JUSTIFICATION FOR REMOVAL OF
ORIFICE ROD ASSEMBLIES IN
THREE MILE ISLAND UNIT 2, CYCLE 1

BABCOCK & WILCOX
Power Generation Group
Nuclear Power Generation Division
P. O. Box 1260
Lynchburg, Virginia 24505

Figure 2.1-1. TMI Unit 2 Reactor Core Safety Limit

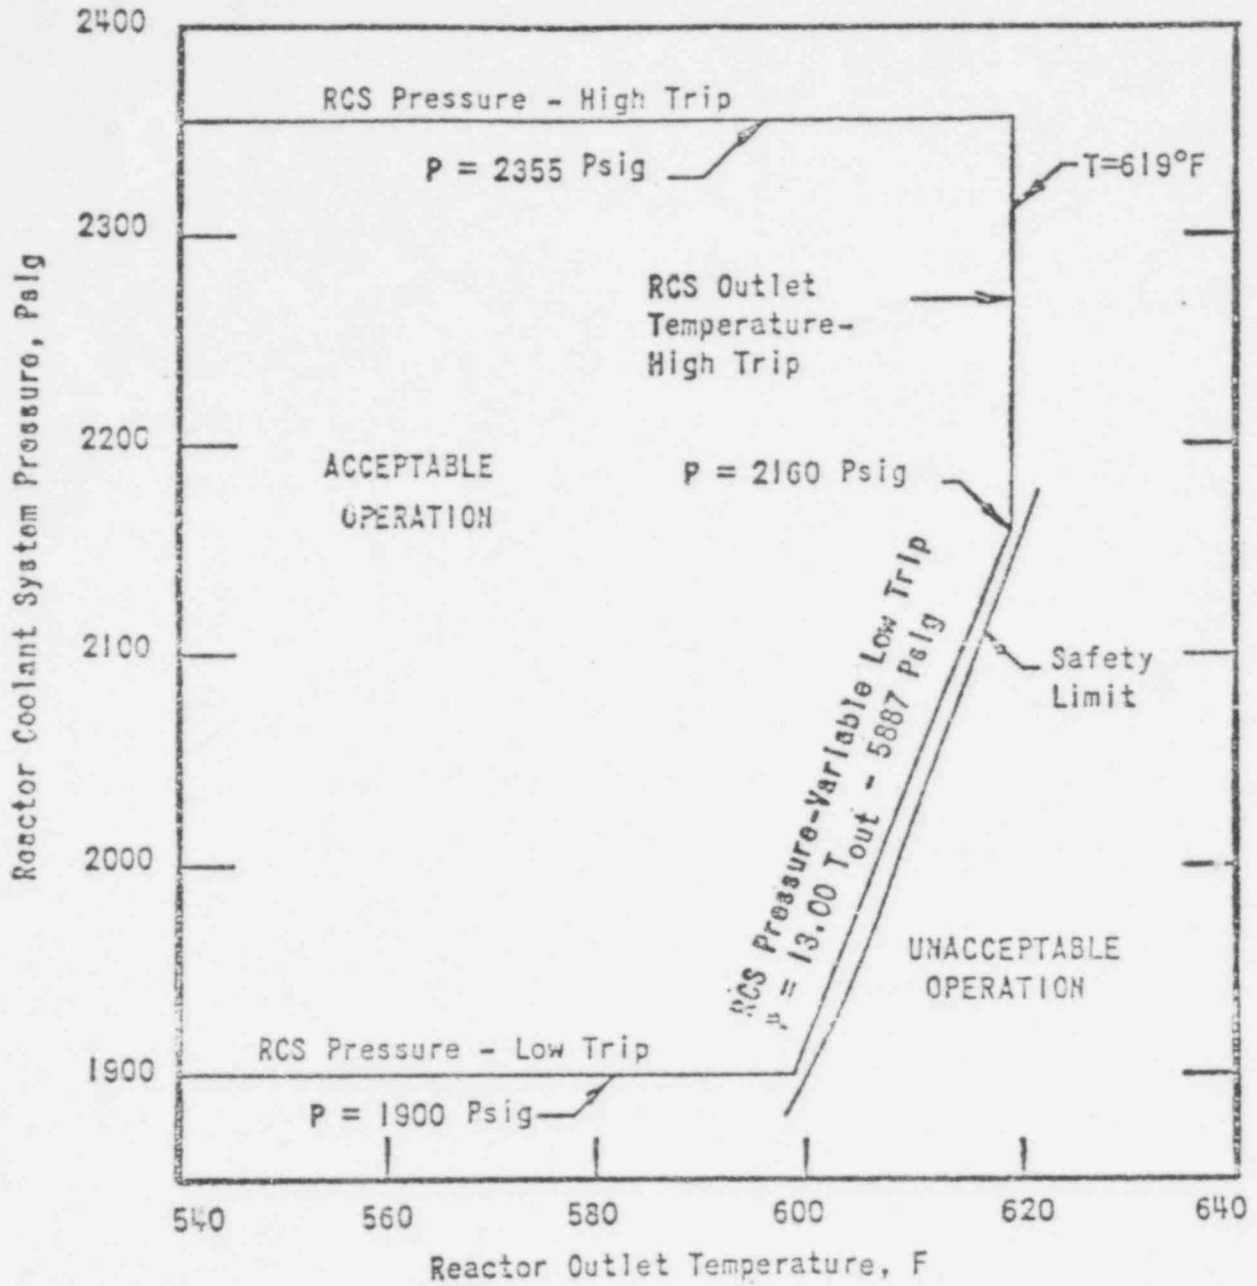
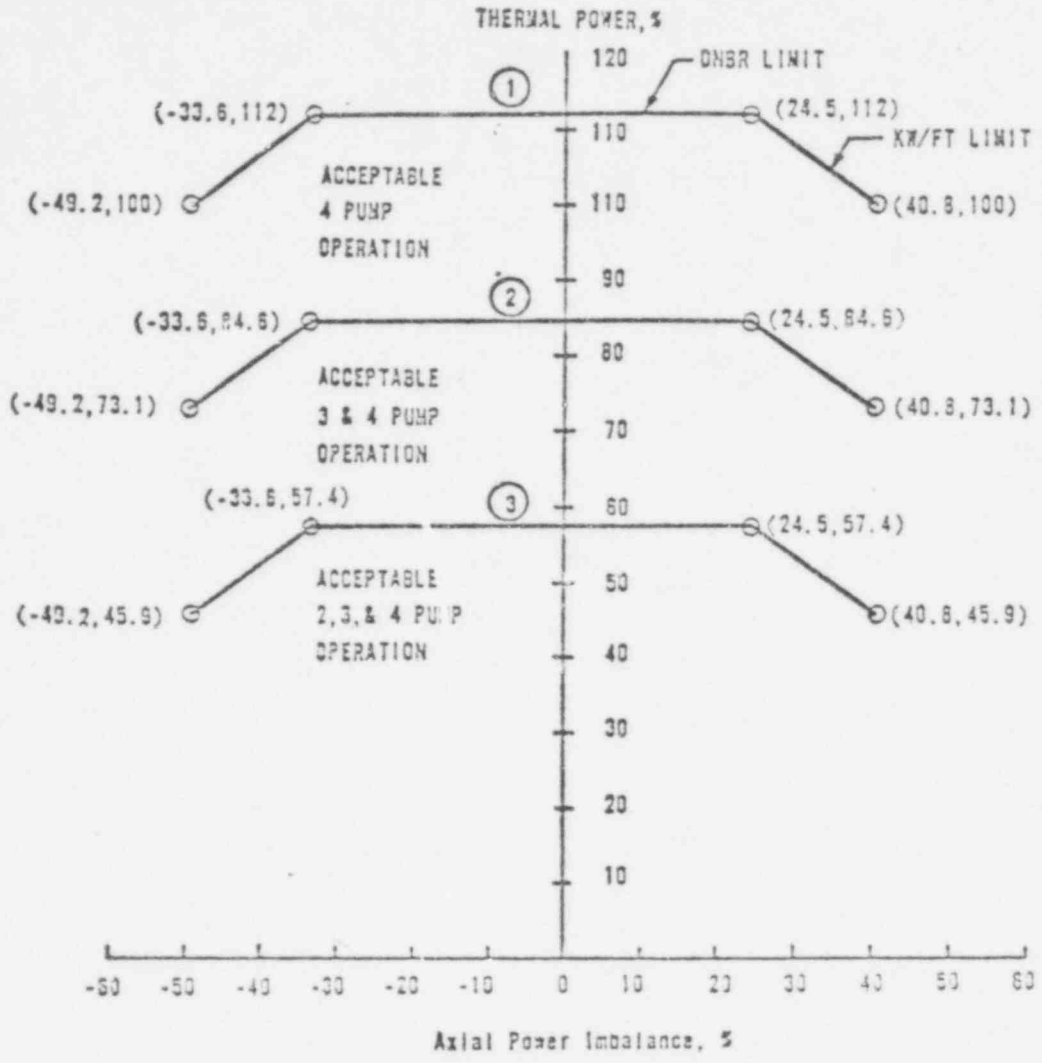
The pressure-temperature limit curves shown in Figure 2-1 (section 5 of this report) provide the basis for the variable low-pressure trip setpoint. These curves have been changed from those of bases Figure 2-1 of the TMI-2 Technical Specifications.⁴ The revised pressure-temperature limits cover an 11.2% fuel rod bow penalty, based on an assumed maximum assembly burnup of 33,000 MWd/mtU, while incorporating the core flow changes discussed above.

1. The pressure-temperature limits have been revised to incorporate the affects of ORA removal, retainer installation, and rod bow penalty.
2. System flow of 102% of design flow was used.
3. The low pressure setpoint has been raised to account for the LOCA small break analysis (backup function only).
4. Instrument drift numbers have been included for calibration drift in accordance with item 2.C.(3)f. of the operating license.

Figures 2.1-1, 2.1-2, 2.2-1, 2.2-2, and 2.1 (Tech Spec numbering) illustrate the revisions to previous Technical Specification limits.

Figure 2.2-1. Trip Setpoint for Nuclear Overpower Based on RCS Flow and Axial Power Imbalance

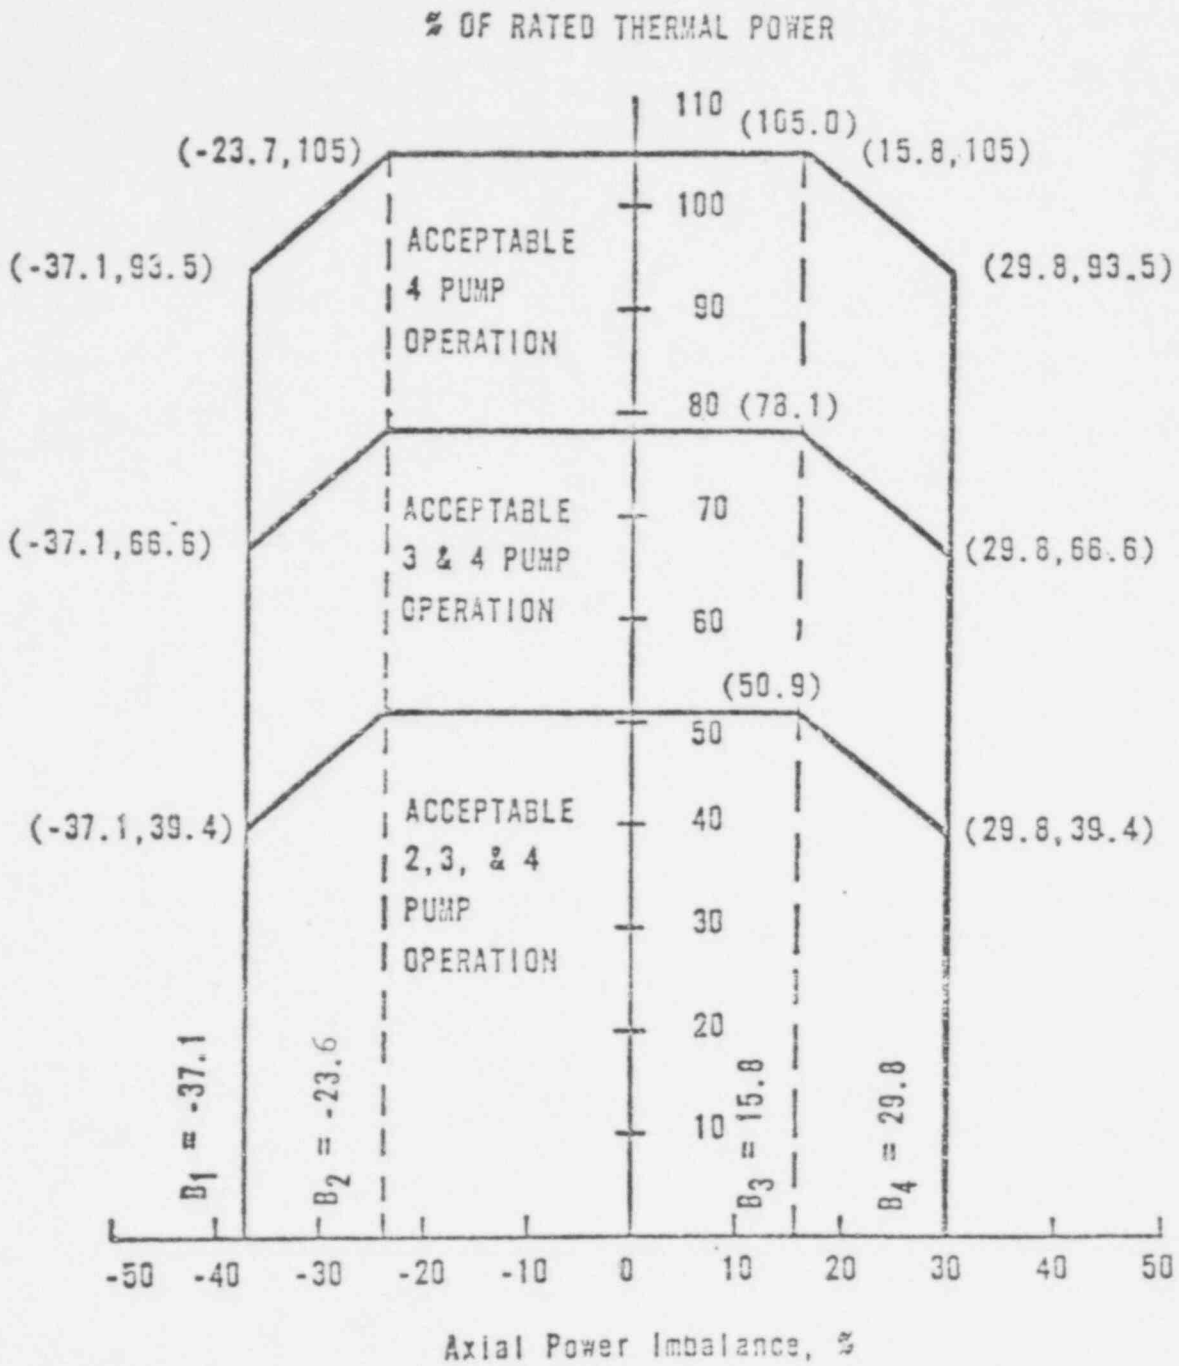
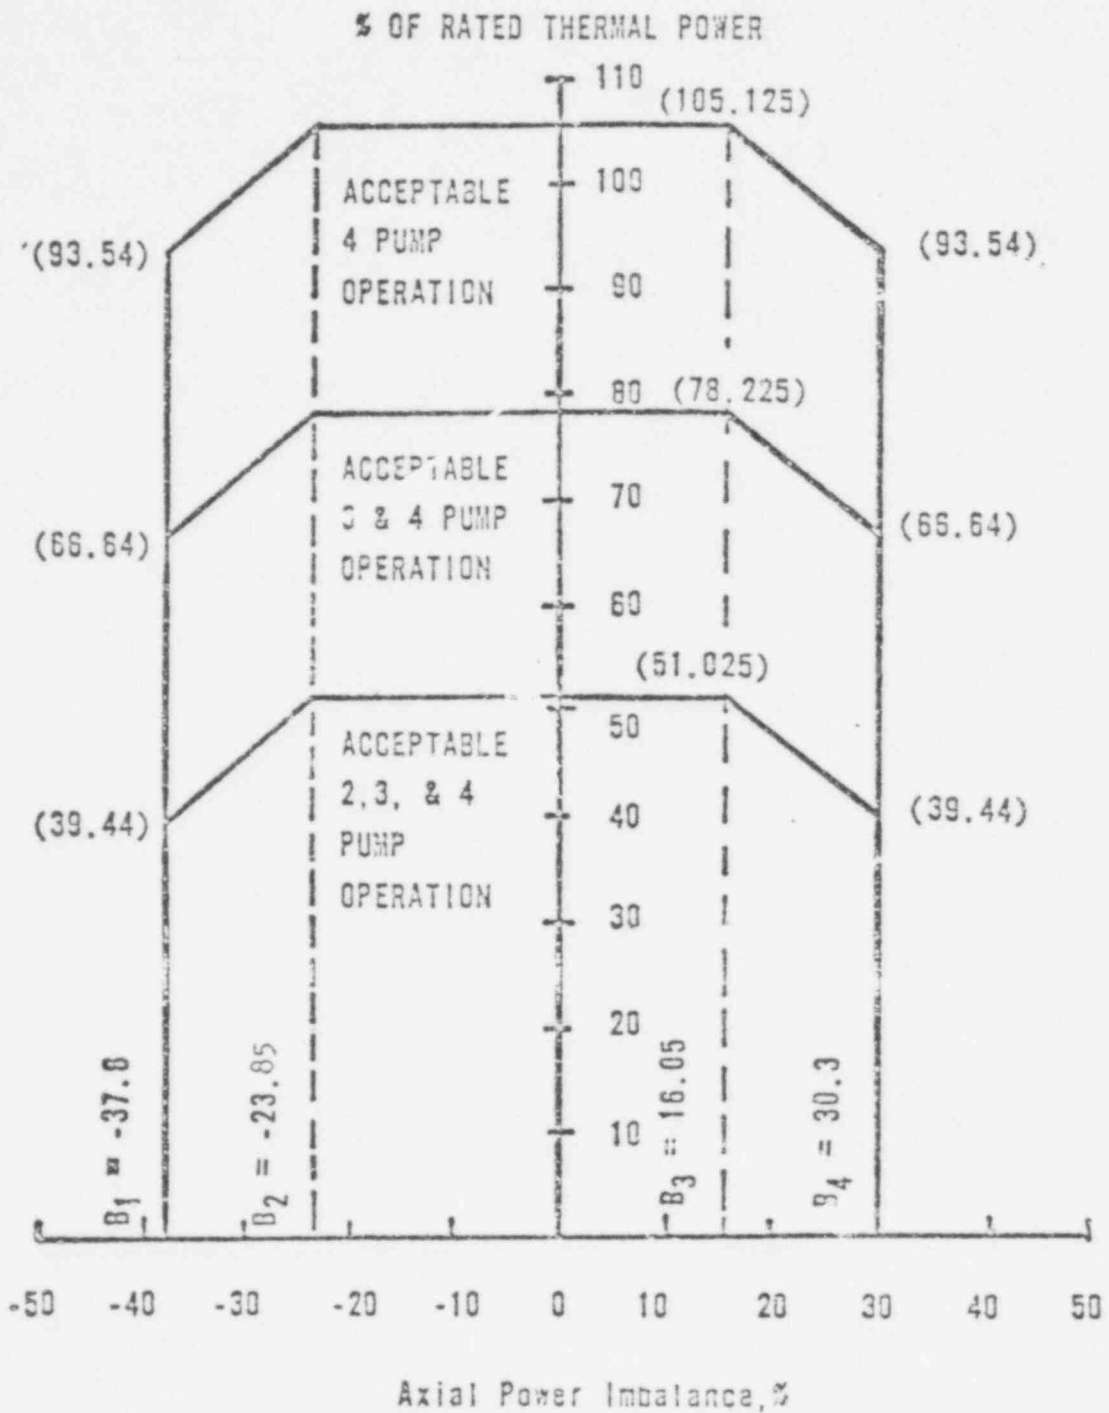
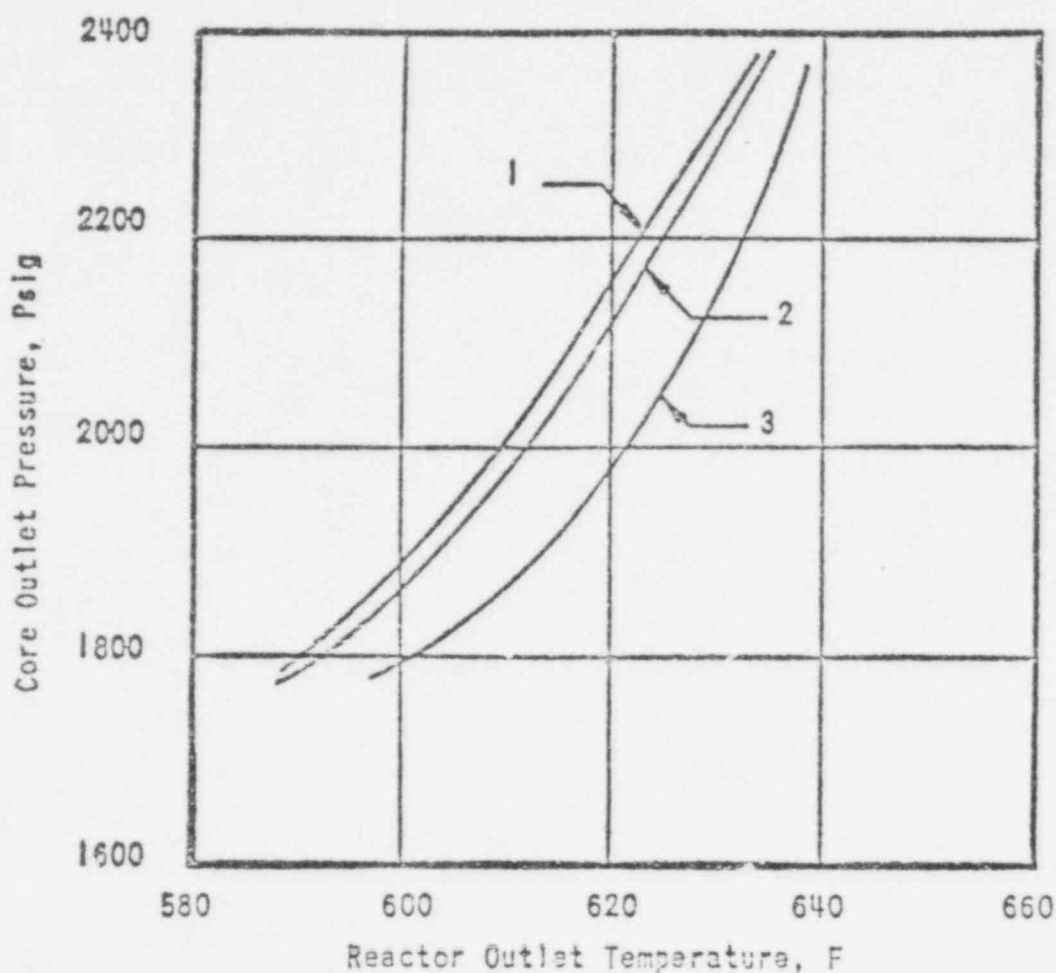
The flux/flow trip setpoint was determined by analyzing an assumed one-pump coastdown starting from an initial indicated power level of 102%. The Technical Specification flux/flow setpoint of 1.05 was re-evaluated based on the initial conditions determined with the ORAs out. The 1.05 setpoint provides coverage of a 9.1% rod bow penalty in the analysis. The maximum cycle 1 burnup is 19,422 MWd/mtU. Using this burnup, a rod bow penalty of 9.1% is calculated. A thermal margin credit equivalent to 1% DNBR to offset the rod bow penalty has been used as a result of the flow area (pitch) reduction factor included in all thermal hydraulic analysis. Applying the 1% credit against the 9.1% calculated penalty results in an 8.1% penalty to be applied to the analysis. Therefore, the present flux/flow setpoint provides more than adequate rod bow penalty coverage for cycle 1 operation.
